**SUBDIVISION,
PLANNED UNIT DEVELOPMENT,
PLANNING APPROVAL, &
SIDEWALK WAIVER STAFF REPORT****Date: November 7, 2019**

<u>NAME</u>	West Bay Academy Subdivision, Addition to
<u>SUBDIVISION NAME</u>	West Bay Academy Subdivision, Addition to
<u>LOCATION</u>	1564 & 1568 Hurtel Street and 1567, 1569, & 1577 Forrest Street (Northeast corner of Hurtel Street and Antwerp Street, extending to the Southeast corner of Forrest Street and Antwerp Street)
<u>CITY COUNCIL DISTRICT</u>	District 3
<u>PRESENT ZONING</u>	R-1, Single Family Residential District
<u>AREA OF PROPERTY</u>	1 Lot / 1.6± Acres
<u>CONTEMPLATED USE</u>	Subdivision approval to create one legal lot of record, Planned Unit Development Approval to amend a previously approved Planned Unit Development to allow multiple buildings on a single building site, Planning Approval to amend a previously approved Planning Approval to allow the operation of a church with a daycare in an R-1, Single-Family Residential District, and Sidewalk Waiver for construction of a sidewalk along Forrest Street.

SITE PLAN

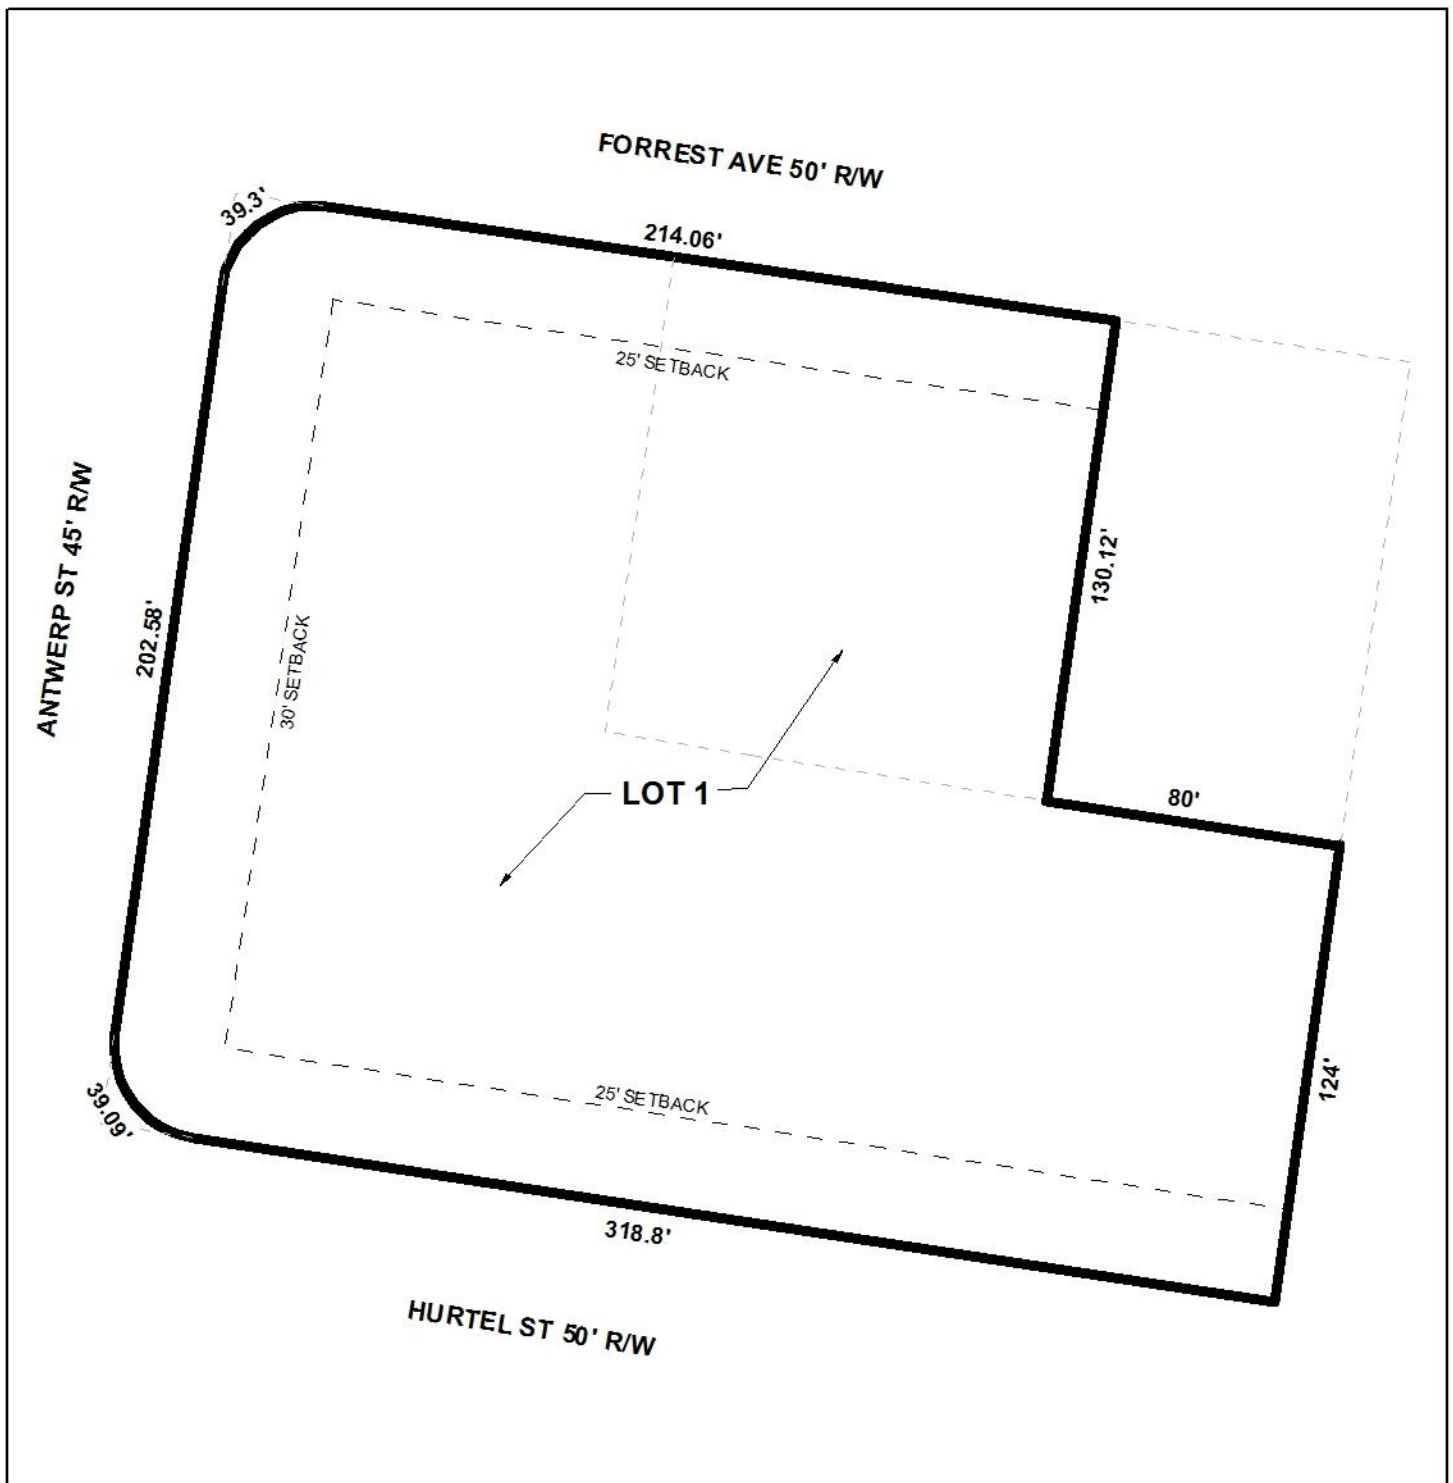
The site plan has been revised to depict four parking spaces and an “existing dumpster” on the building slab of 1564 Hurltel Street. It should be noted that the slab has the ability to provide more than four parking spaces, and the depicted arrangement of parking spaces does not meet the minimum requirement of the Zoning Ordinance as it relates to access and maneuvering. Thus, a compliant parking lot layout should be provided for the existing slab, and abutting landscape areas should be protected from vehicle intrusion via curbing or parking bumpers.

Furthermore, the “existing dumpster” may currently be on the site, but it has been added to the site since the unpermitted demolition of 1564 Hurltel Street, and therefore does not have a compliant sanitary sewer connection, or enclosure. It is especially interesting to note that the site plan states “This site will be served by private can collection service or curbside collection service”. If the site is indeed, to use curb side pickup, then the dumpster should be removed from the site. If the existing dumpster is going to be utilized by the church or daycare at all, it should be required to obtain after-the-fact permit, and comply with all Zoning Ordinance requirements in regards to dumpsters.

The site plan does provide tree and landscaping calculations showing what is required, but does not provide the amount of actual landscape area provided. If approved, the site plan should be revised to include these calculations so that staff can insure the site is compliant. The site has a large amount of substantial trees on the site, which staff used to count both as tree credits, as well as reduce the number of trees required to encourage the principles of right-tree/right-place. After all of the credits available to the site, it appears that the only new tree plantings that would be required would be two overstory trees along Hurltel Street in proximity of the slab used for parking, and two overstory trees along Forrest Avenue.

The revised site plan does not depict any driveways along Forrest Avenue. Since the applicant is not depicting any access to Forrest Avenue, the existing curb cuts should be removed from the site. Furthermore, no vehicular access should be allowed on unimproved, unpaved surfaces.

- 1) Revision of the site plan to illustrate a compliant parking lot layout for the existing slab, and abutting landscape areas protected from vehicle intrusion via curbing or parking bumpers; and*
- 2) Either removal of the “existing dumpster” from the site; or removal of the note stating that curb side pickup will be utilized, and placement of a note stating that the dumpster will be brought into compliance with sanitary sewer and enclosure.*
